STAFF REPORT

RE: **501 Front Street**
(permit application # T2019-0089)

FROM: Karen DeMaria, City of Key West Urban Forestry Manager

CONCH TOUR TRAIN
RENOVATIONS
501 Front Street
KEY WEST, FLORIDA.

A-1

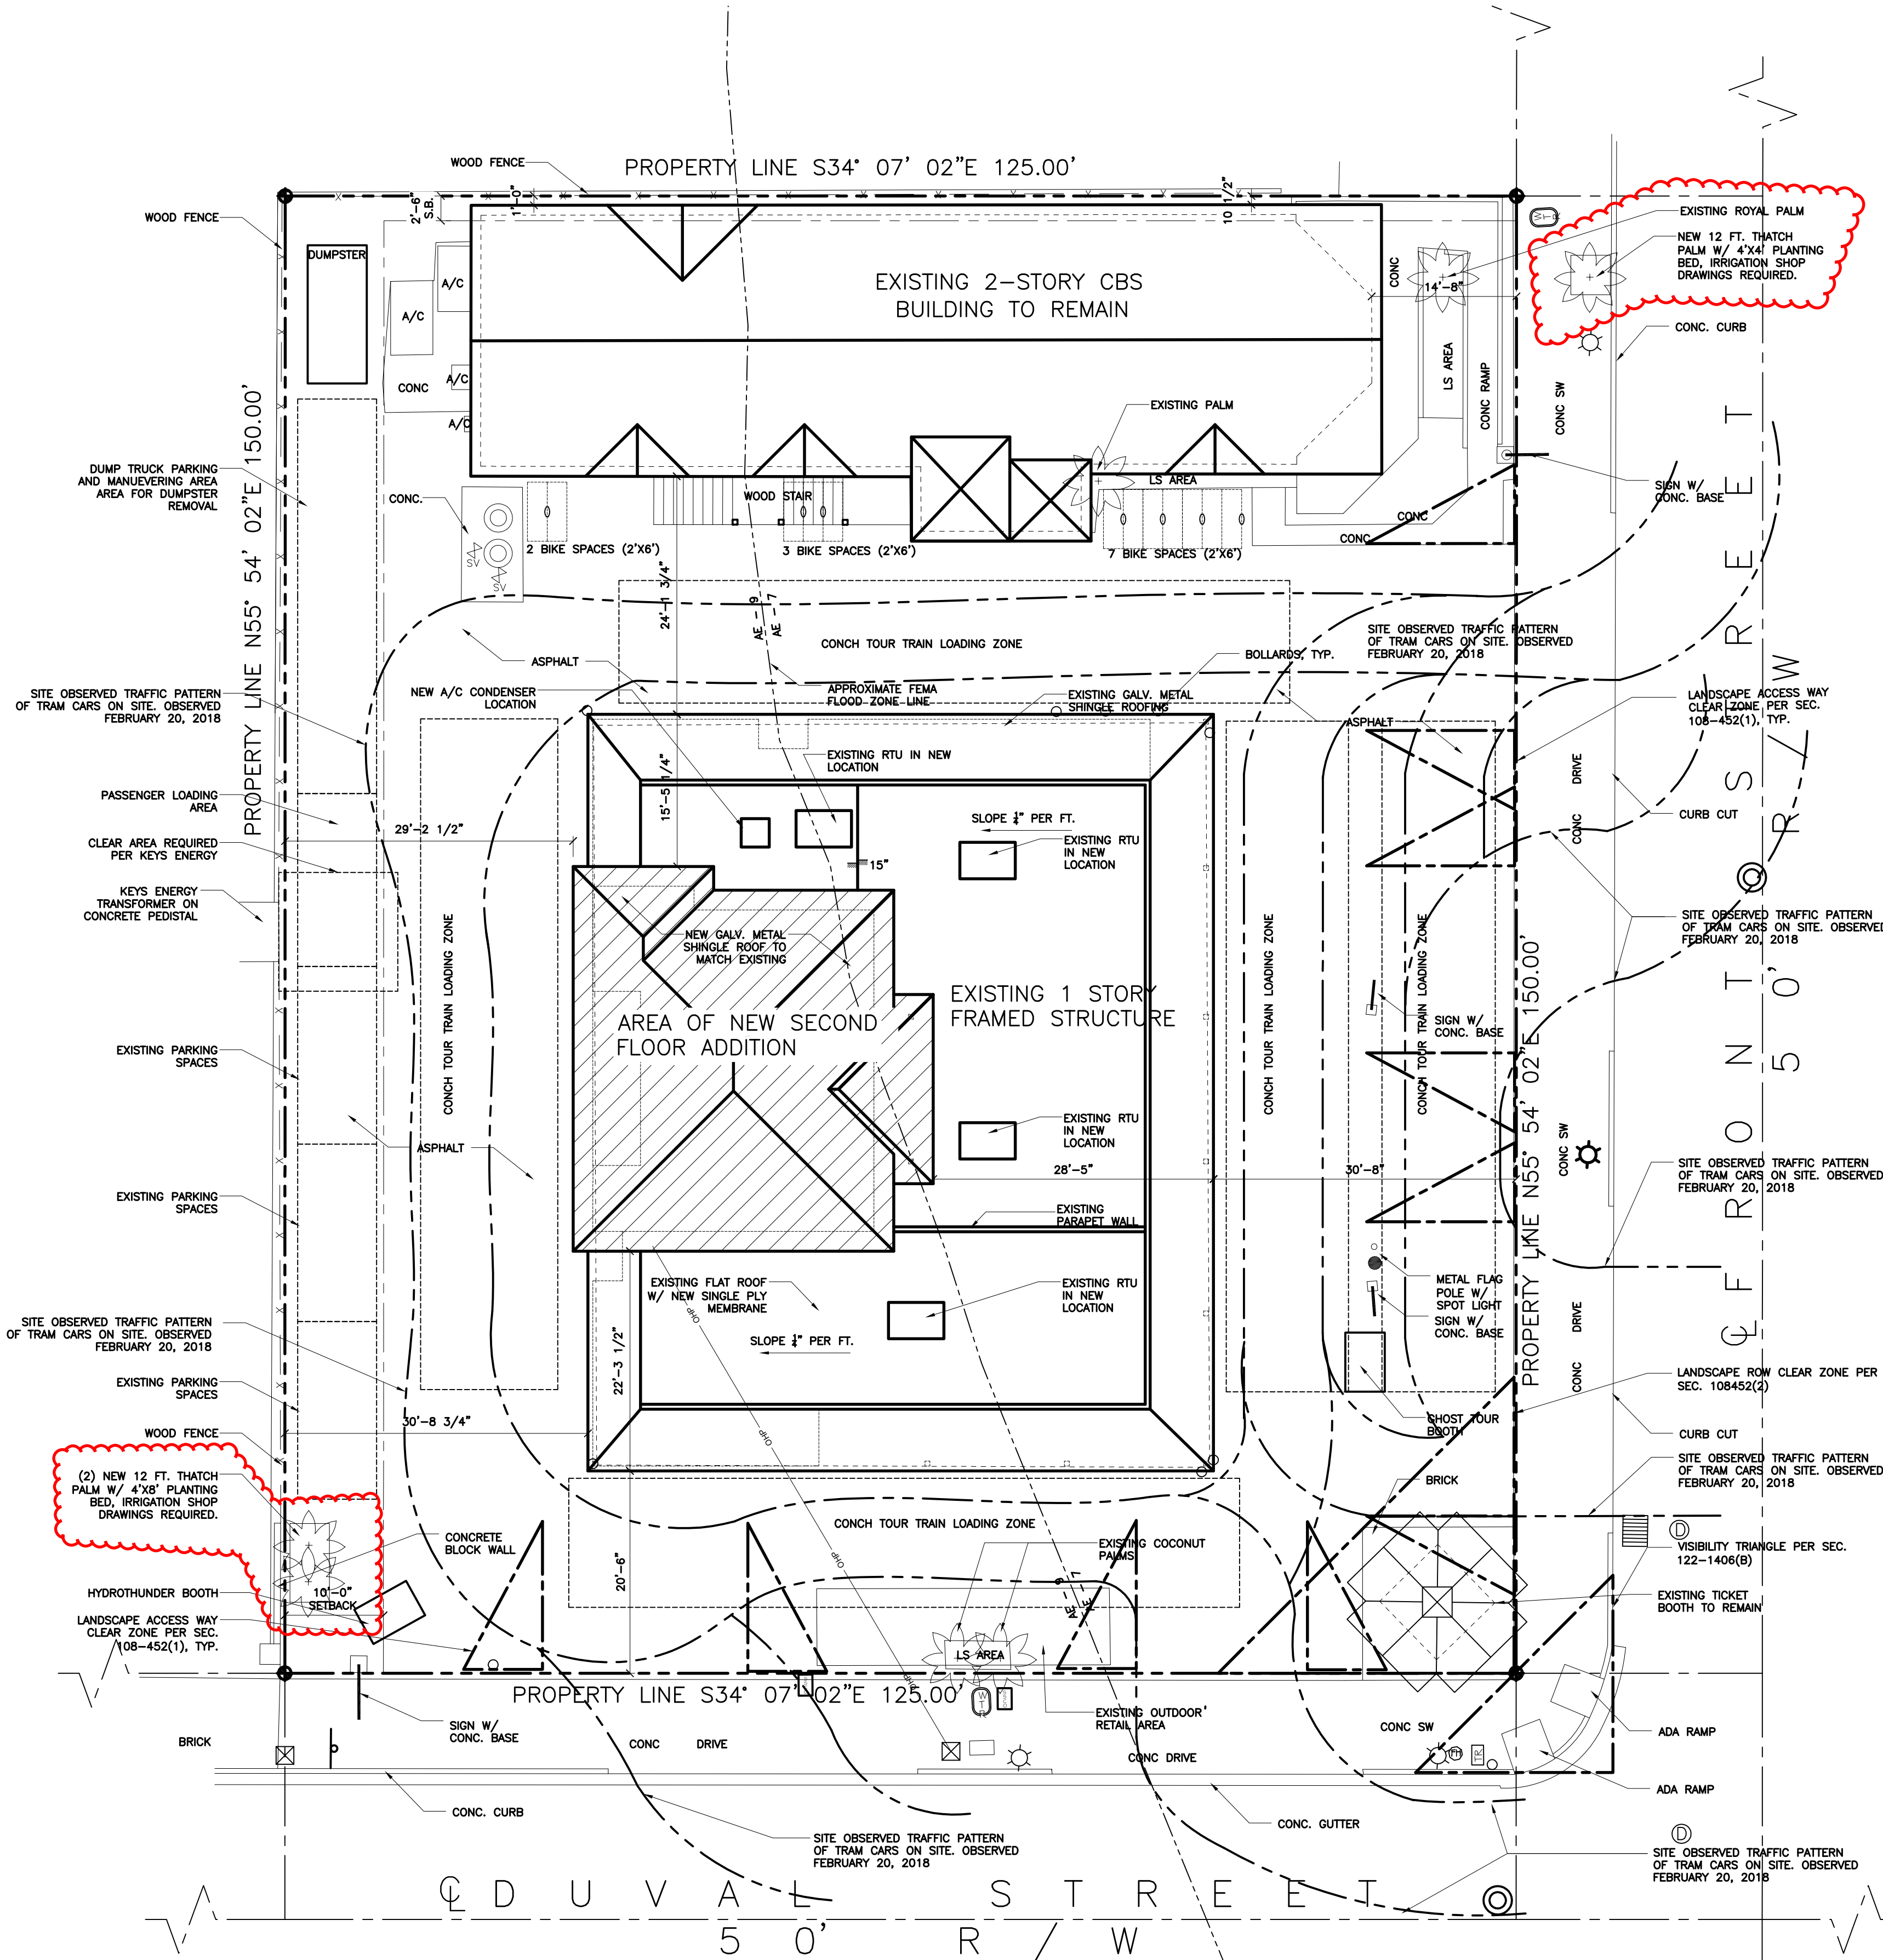
The City Engineer reviewed the submitted plan and made comments (see e-mail exchanges below). Of concern is the area is a high commercial use area with a high frequency of conch train trips in and out of the property, the high volume of pedestrians in the area, and the high traffic use of the area by vehicles and bikes. There is a potential for line of sight issues even with palm trees due to the volume of uses in the area so he did not recommend the creation of any new planters except possibly two new planters by Ron Jon.

Proposed Planting Area 1:

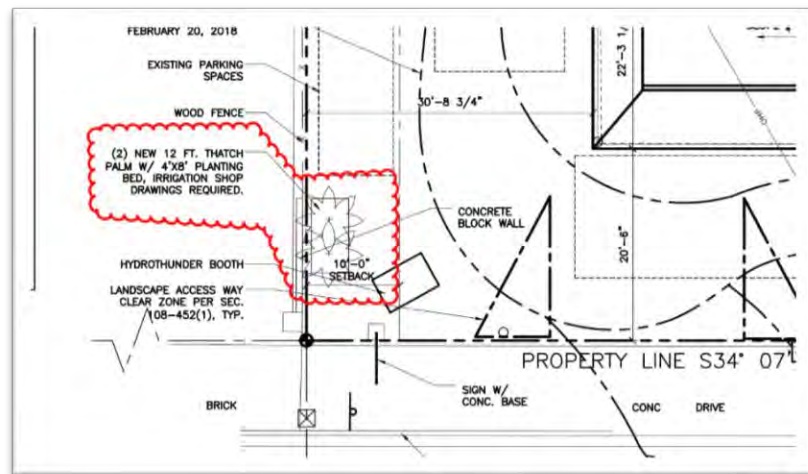
In the NW Corner of the property, we identified a 4'x4' area that can safely accommodate two mature Florida Thatch Palms as depicted to the right.

Proposed Planting Area 2:

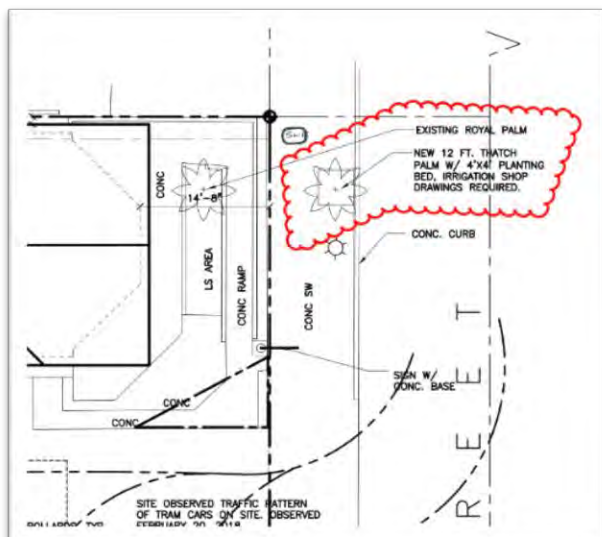
In the SE Corner of the property, we identified a 4'x4' area in the public sidewalk that can safely accommodate one mature Coconut Palm as depicted to the right.

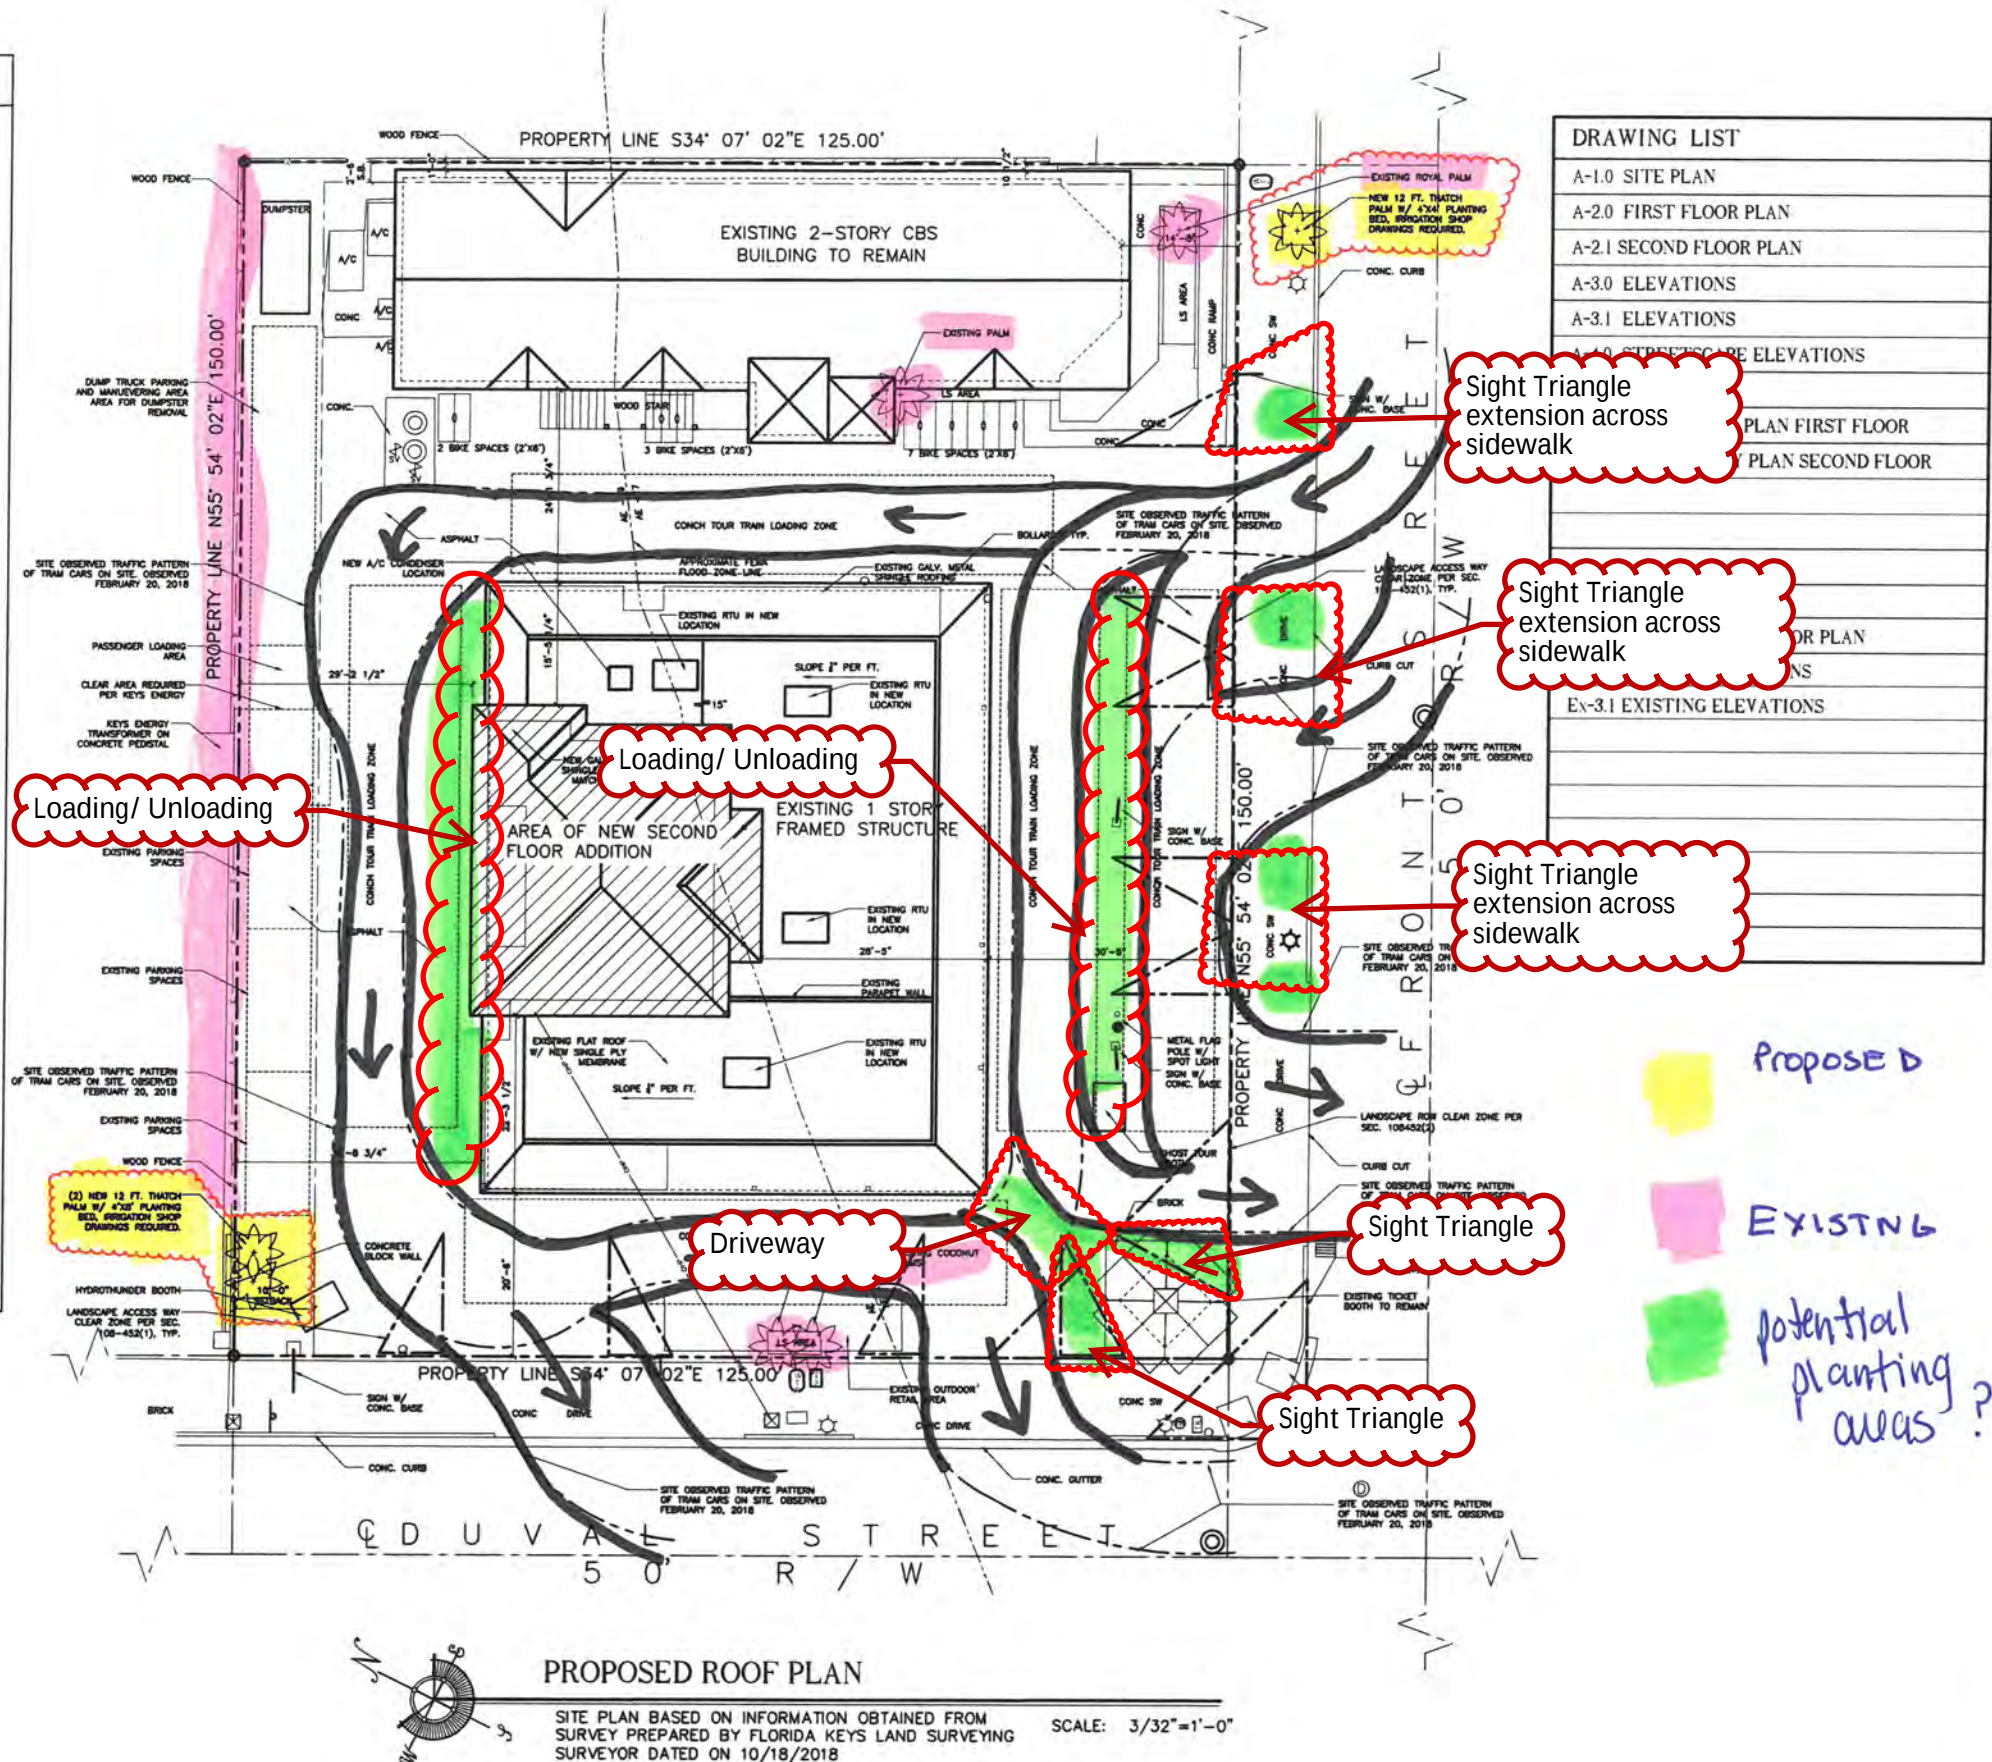
I've read through your letter and want to get some clarification:

I have attached a color coded map. In green are areas that I previously identified as being potential planting areas. Your letter makes some statements that possibly relate to these areas. Would it be correct to state that your letter and the comments about line of site and planting being impractical are accurately represented by the areas in green? I have also asked Kelly to comment on this map so that there is something in the file from him regarding your meeting and discussions.

Right now I am seeing that your client will create one new planter on the property (plant two Thatch Palms) then create one new planter on City ROW (plant one Thatch Palm).

Thanks for the email. I am sorry the plan wasn't clear enough. I appreciate you marking it up and sending it. I marked up your plan in an attempt to explain the situation more clearly. The areas you identified are not plant-able. They are a mix of driveway, loading and unloading, and the extension area of the required clear sight triangles across the public sidewalks. We reviewed these areas extensively. The only area which will not create potential conflicts or block sight triangles are the areas proposed. We certainly wish we had more area to plant, but the unfortunate reality is we do not.
